**Subject: Assumption of Geotechnical Engineer of Record, Geotechnical Update, and Response to City of San Diego Review Comments (PRJ- 1132845)
Bunker Hill Multi-Dwelling Units
2917 Bunker Hill Street, APN No. 424-321-21-00
San Diego, California 92109**

Response to City of San Diego Review Comments (PRJ-1132845)

Liquefaction analysis overall plots

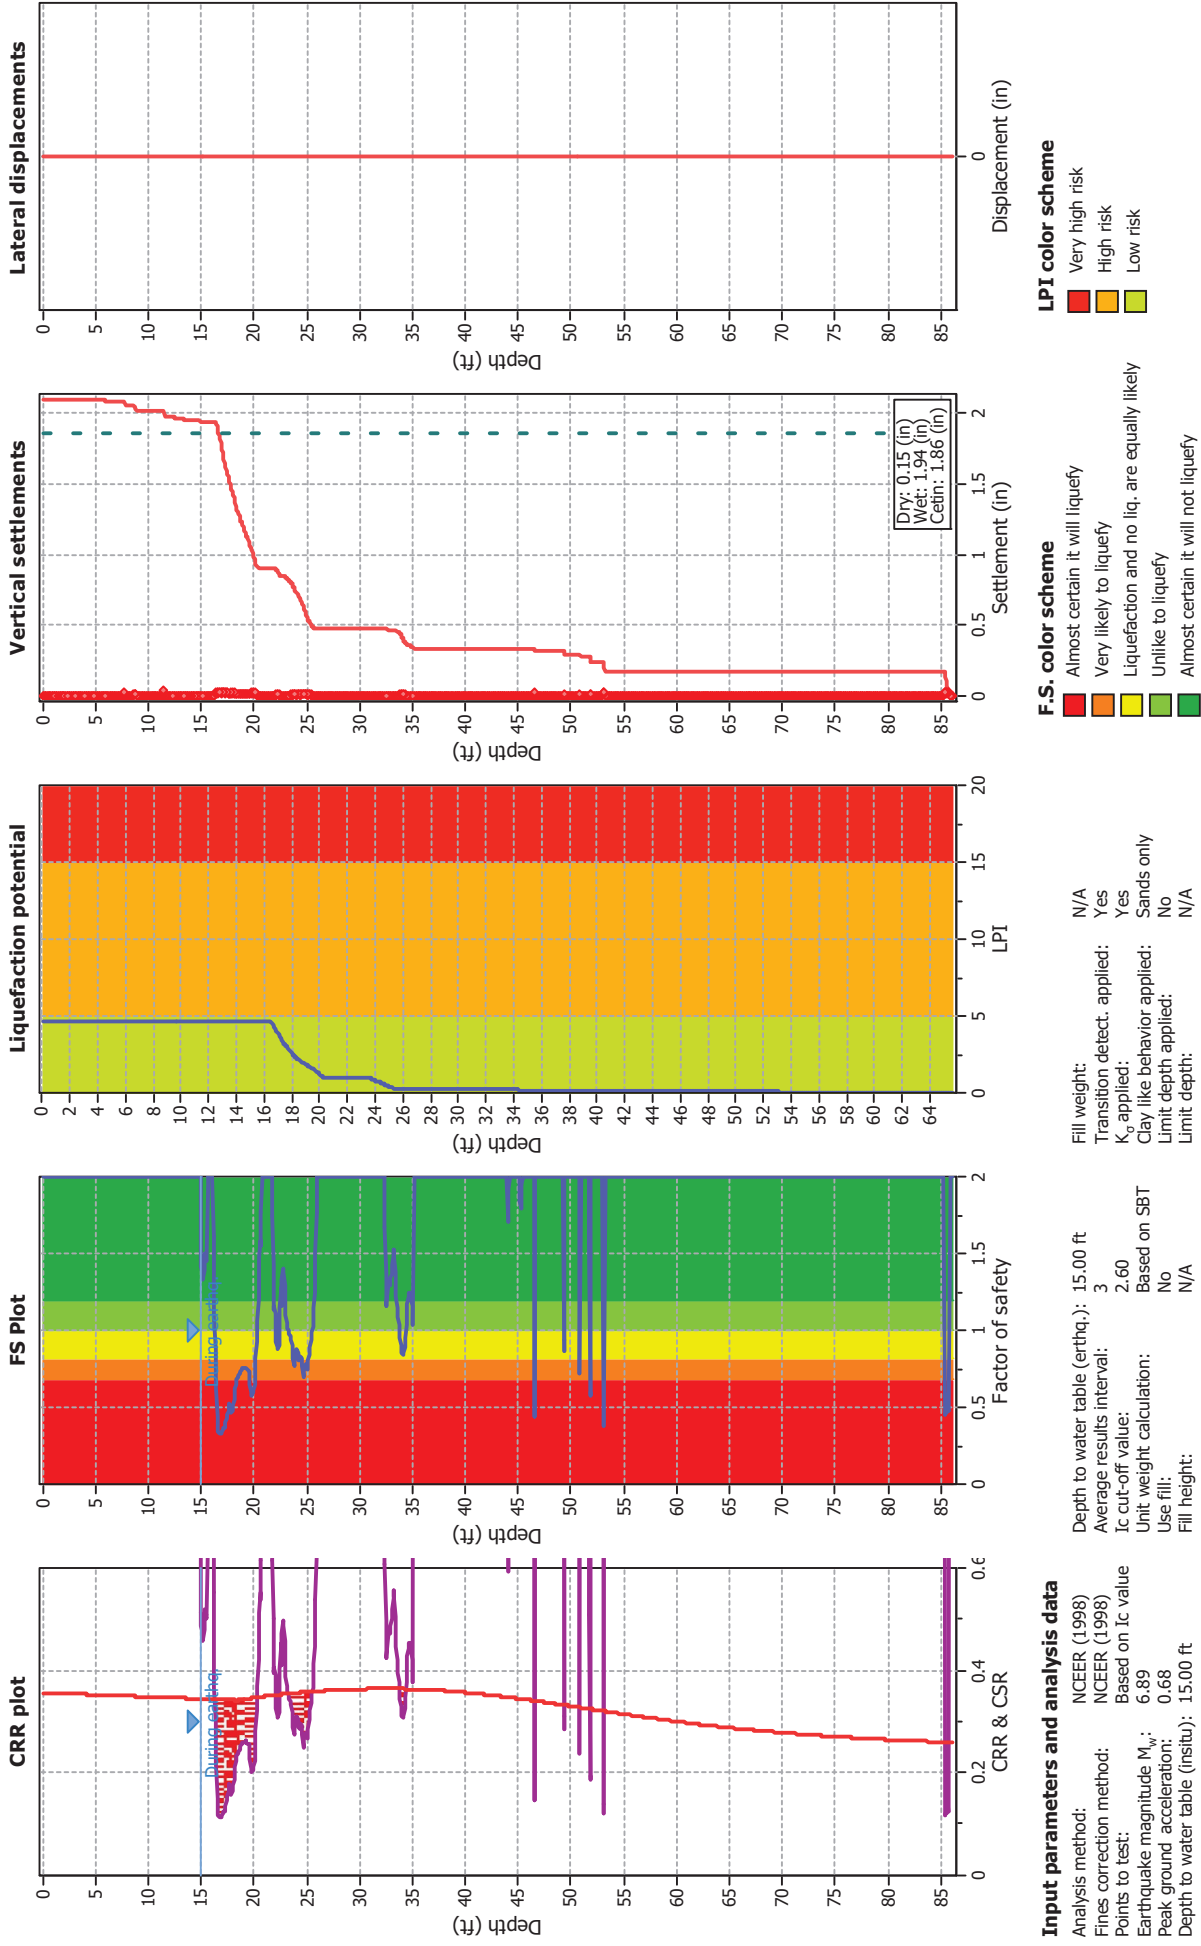
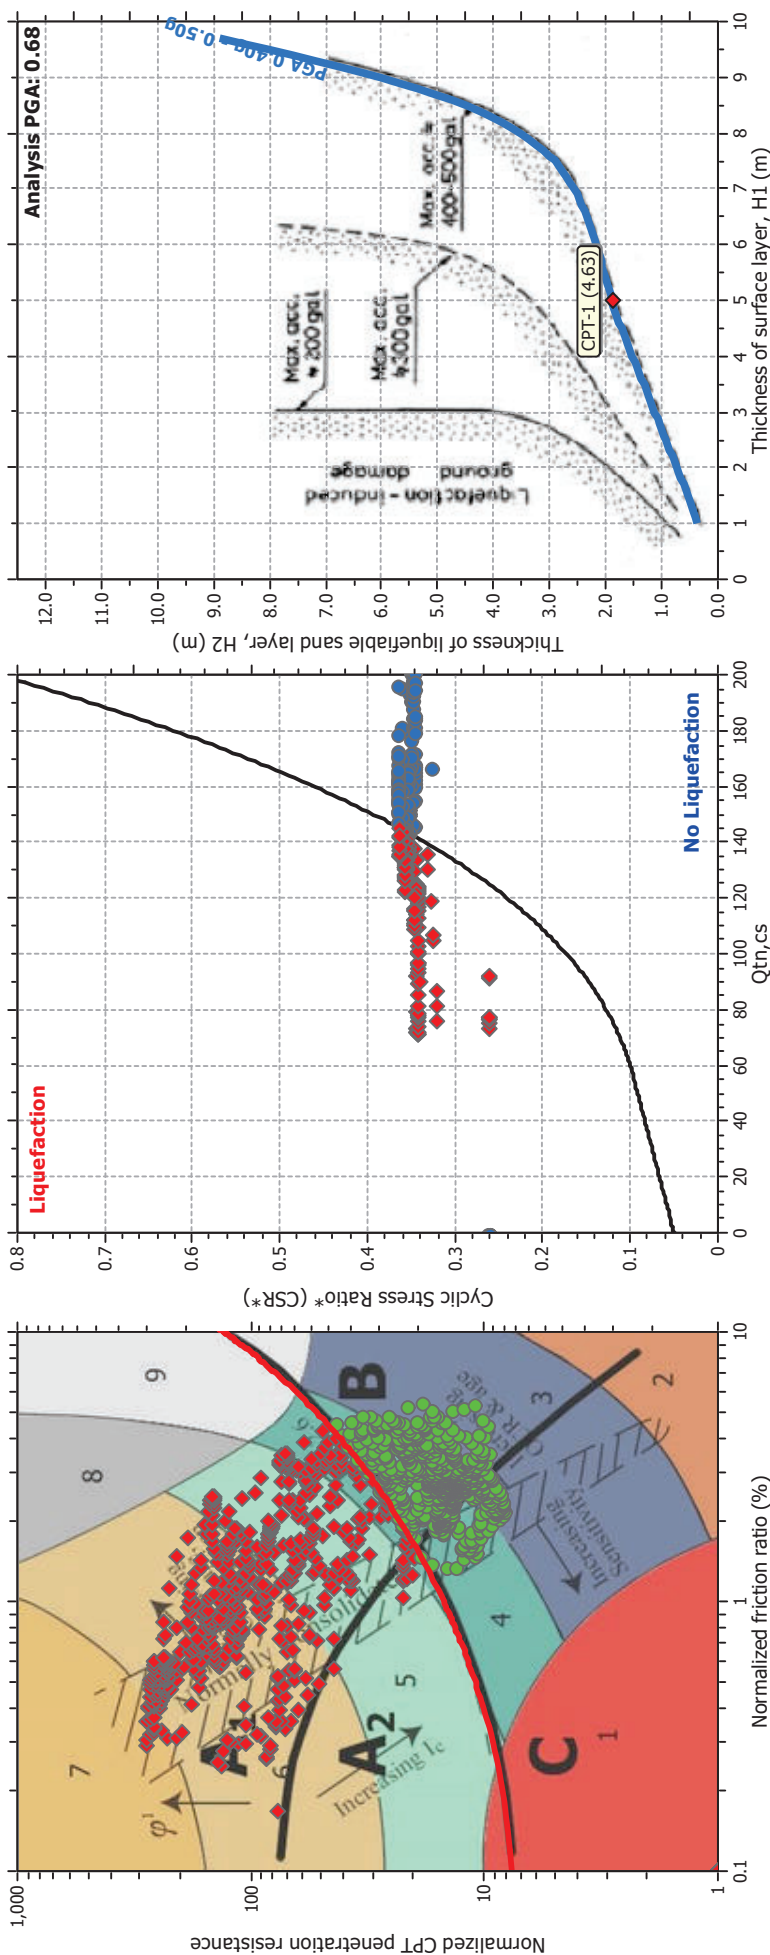
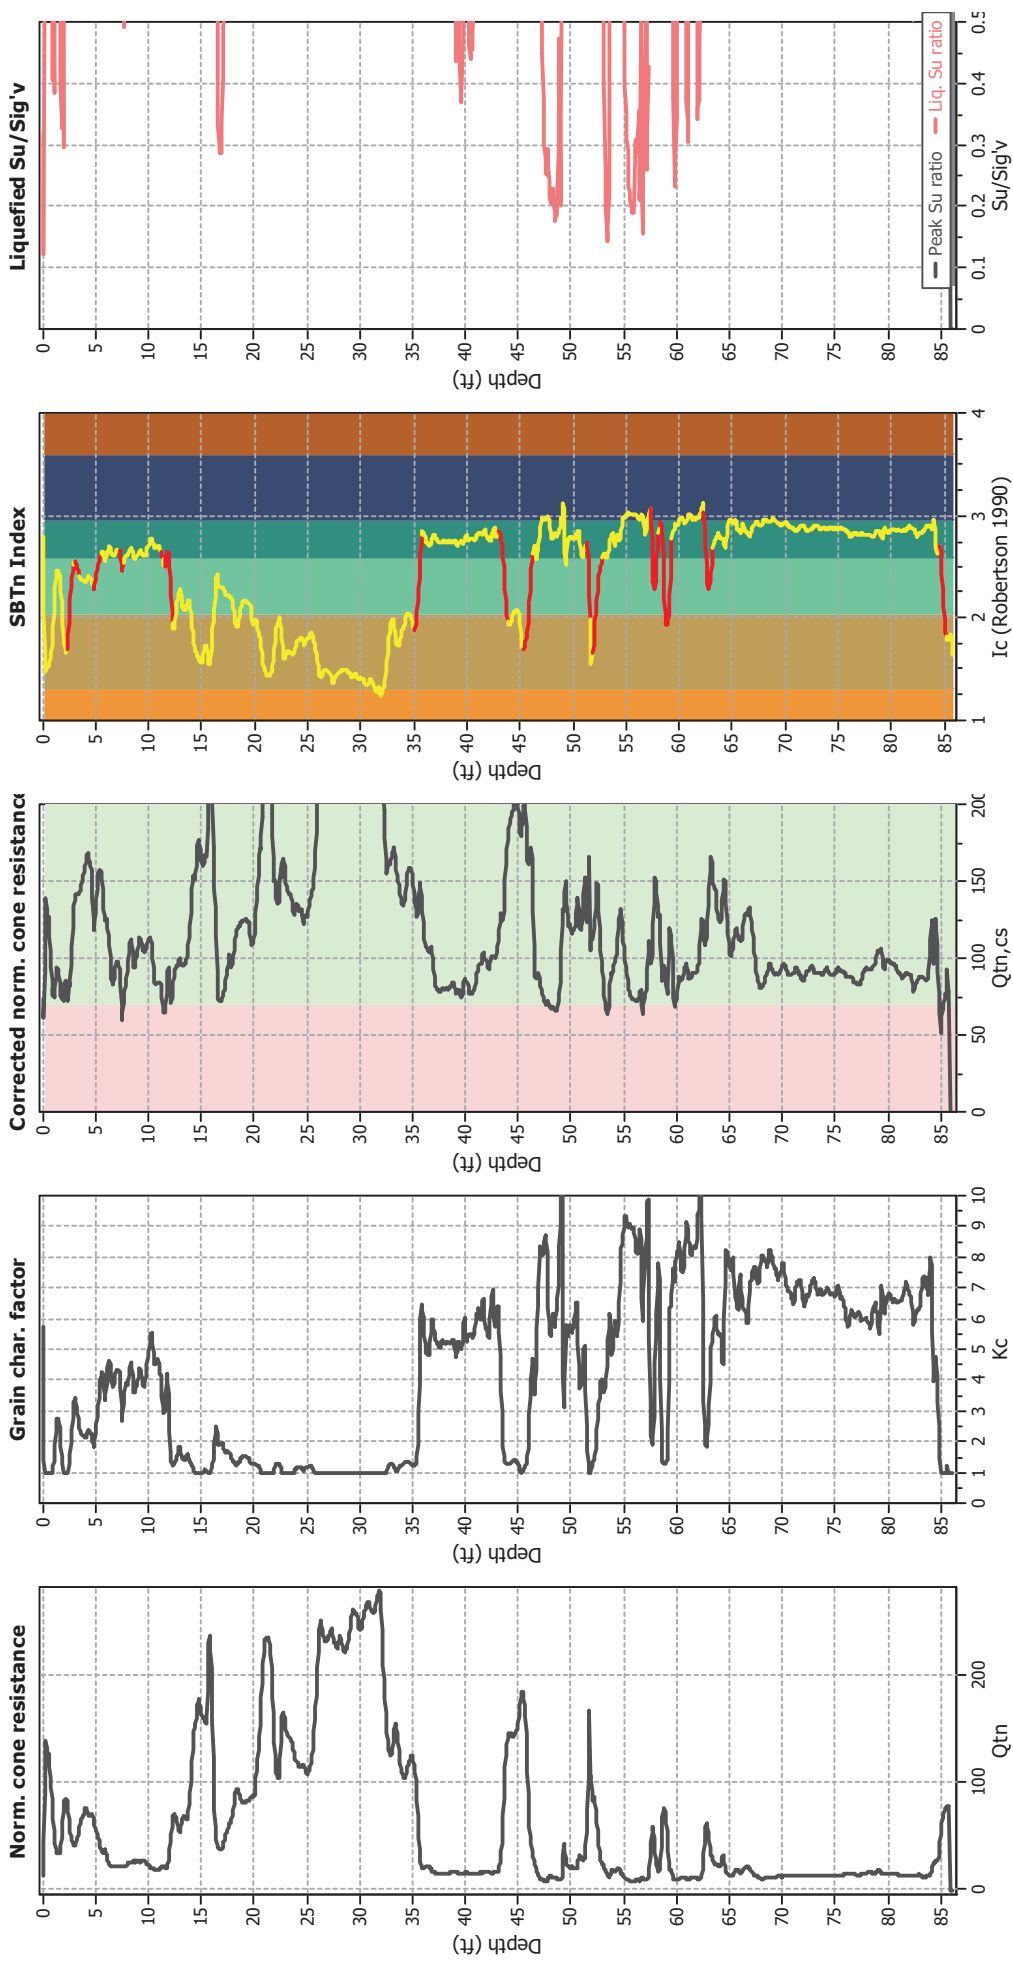
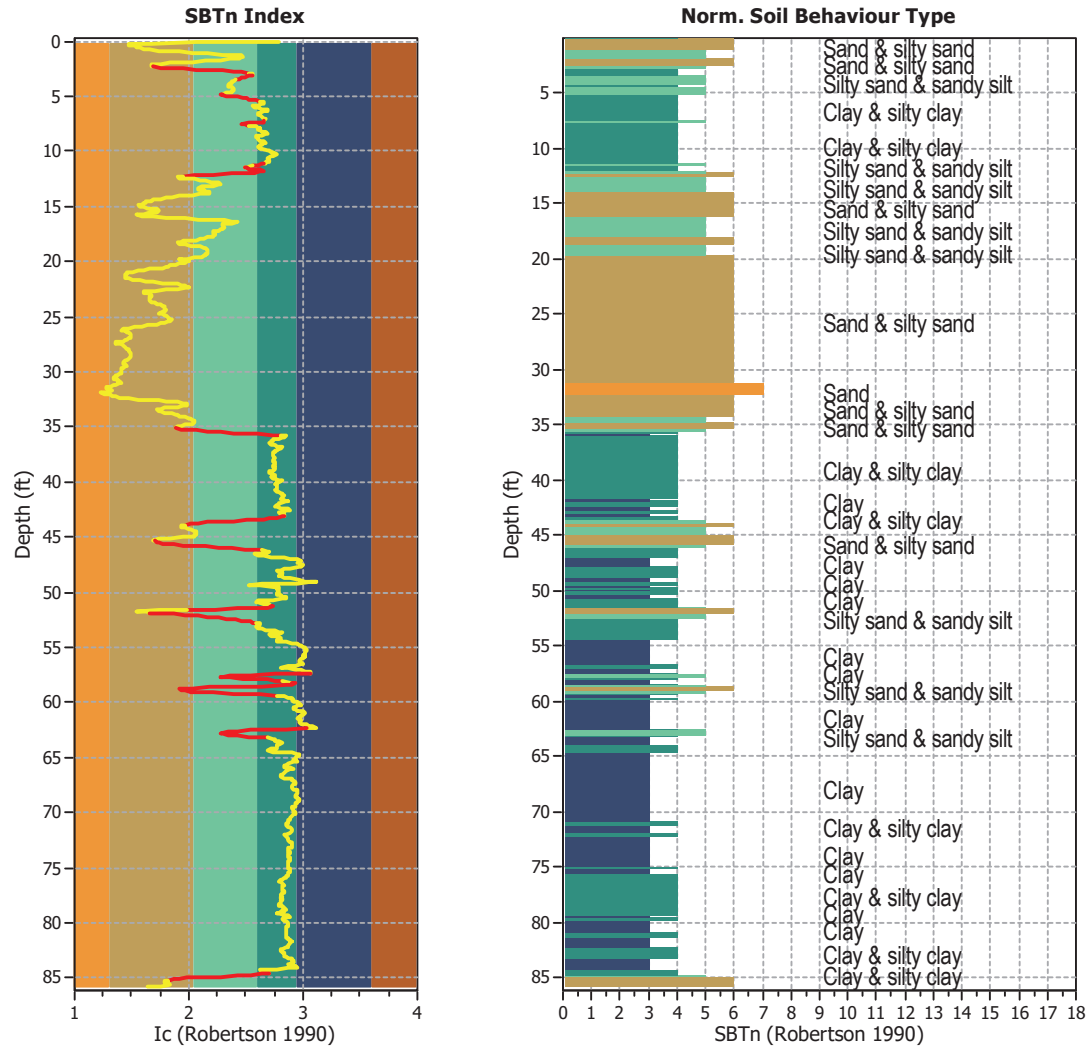
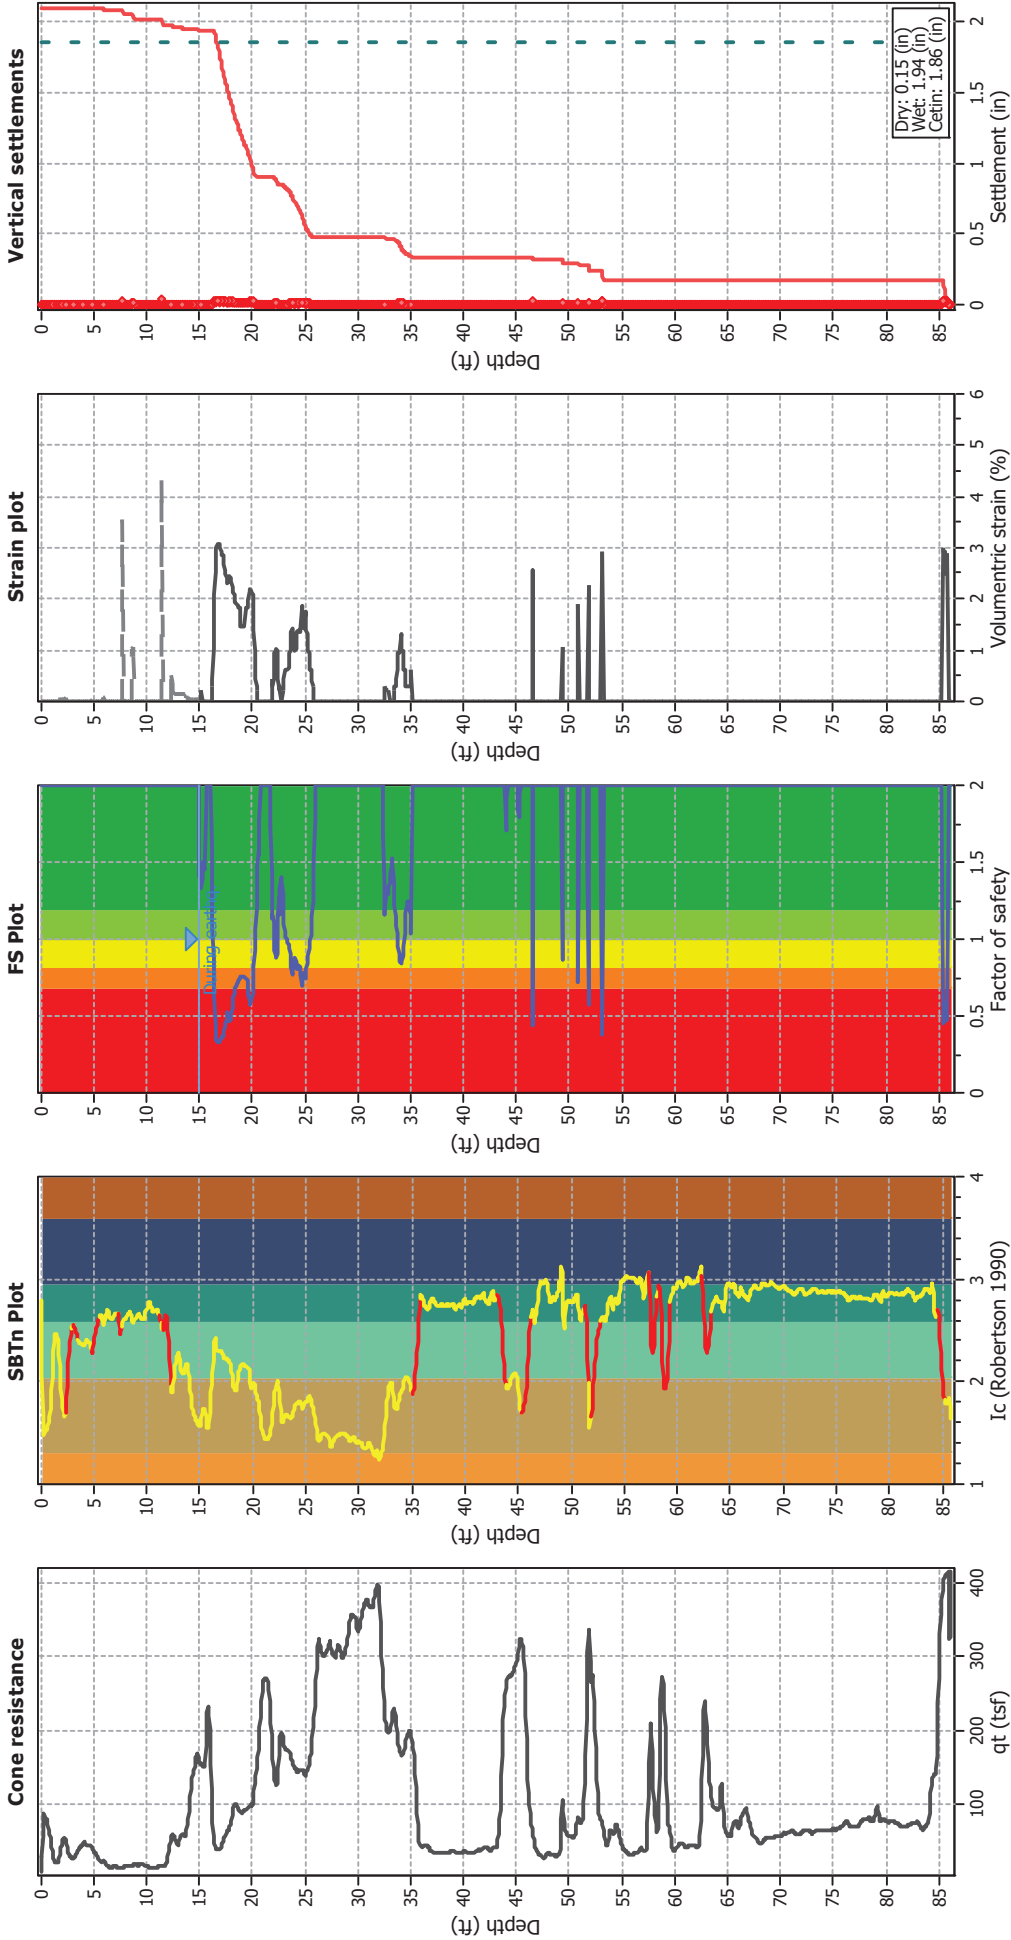
Comment 40: *Explain why the depth of the liquefaction analysis was limited to 30 feet for CPT-1.*

Response: Following review of the referenced geotechnical report (NOVA, 2023a), it appears the material below a depth of 30 feet (Old Paralac Deposits) was assumed to not be liquefiable based on the geologic age of deposition, which is of the early Pleistocene. However, based on our review of the geotechnical investigation, including blow counts and CPT sounding results, we believe the Old Paralac Deposits are susceptible to liquefaction and should be included in any liquefaction analyses. The revised liquefaction analyses are presented in Appendix A and did not limit the depth of the liquefaction analysis.
